DAUPHIN COUNTY SUBDIVISION/LAND DEVELOPMENT REVIEW REPORT

Municipality	Swatara Township	Surveyor	Terraviz Geospatial		Engineer	Integrated Consulting	
Plat Title	Residential Development at 425 Pear Avenue						
Zoning District	Medium Density Limited Residential District (RM-L)			Proposed Land Use	Single Family Attached Dwellings		
Plat Status:	☐ Preliminary	Plat Type:	☒ Subdivision	Regulations:	☐ County		
	☐ Final		☒ Land Development		☒ Municipal		
	☒ P/F		☐ Combined		☒ Zoning		
	☐ Minor				☒ S&LD		
# of Lots	2	# of New Lots	1	# of DUs	12	Acs Subdiv/Devel	1.23
						Total Acs	1.3
Date Received	6/4/24	Staff Review	6/7/24	Official County Review	6/10/24		
Reviewed by	KMD	Checked by	ARK	Parcel ID	63-018-058 63-019-001

Project Description: To consolidate two existing parcels and construct 12 single-family, attached dwellings and associated improvements

**EXISTING
CONDITIONS
PLAN**

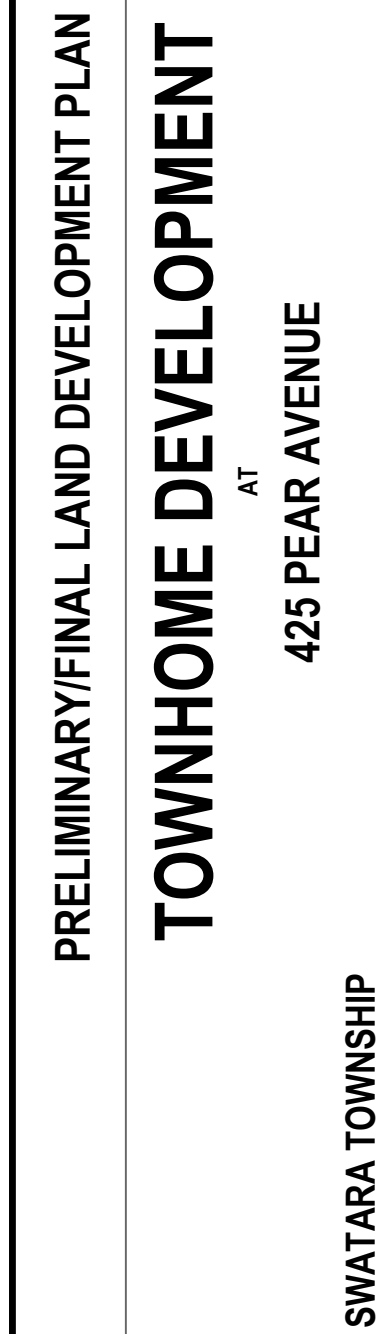
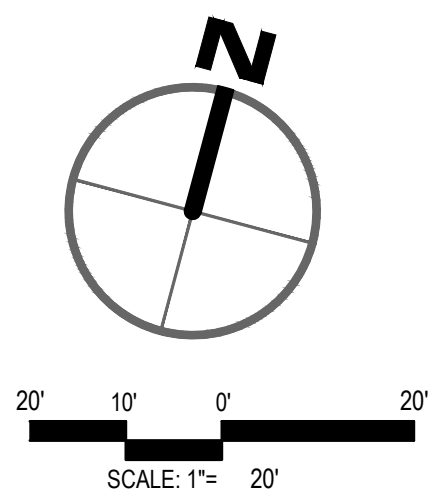
22. Existing streets shown - Name-	X		
R/W width- Pear Street missing		X	
Paving width-		X	
Dedicated R/W width-		X	
23. Proposed streets shown – Name			X
R/W width			X
Paving width	X		
Profiles	X

SITE PLAN

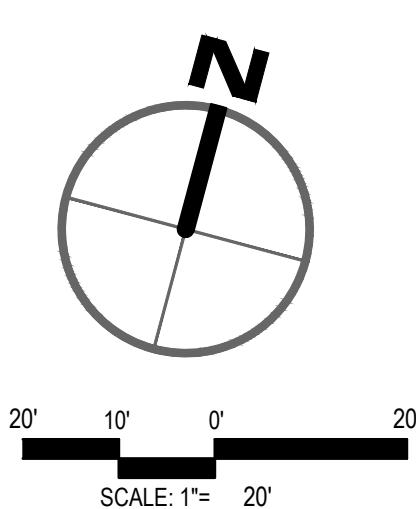
23. No fence, wall, or hedge shall obstruct the sight distance as required by Z.O. § 295-123.C and/or S&LDO §253. A clear sight triangle would be helpful where the access drive enters Pear Street/Plum Avenue.

24. Fences and walls are permitted by right in all districts. Any fence located in the required minimum front yard of lot in a residential district shall not exceed four feet in height. A taller height may be approved by the Zoning Officer if necessary to address a specific hazard. (Z.O. §295-96.D.7.c.1) Note that fences not in a residential district have a maximum height of four feet. The proposed basin fencing is eight (8) feet. The proposed front yard setback is 25 feet, and the basin fencing is proposed to be built at a 10-foot setback.

3. Will the existing right of way line for Cedar Avenue also be vacated?
4. The proposed replaced pavement area for Pear Street and Plum Avenue is approximately 8 feet wide. Given the increase in traffic (two-way) shouldn't the pavement area be widened?

5. Table 1 in S&LDO §253-16 addresses street widths. The current right-of-way measurement for Pear Street is about 16 feet and does not meet the requirement for an alley or private service drive. Plum Avenue's right-of-way is 20 feet and would only meet the cartway requirements for a service drive or alley. How would this impact emergency and other large vehicles? Should this be considered one-way? Also note that an alternative entrance, Pear Avenue has a right-of-way width of 40 feet.
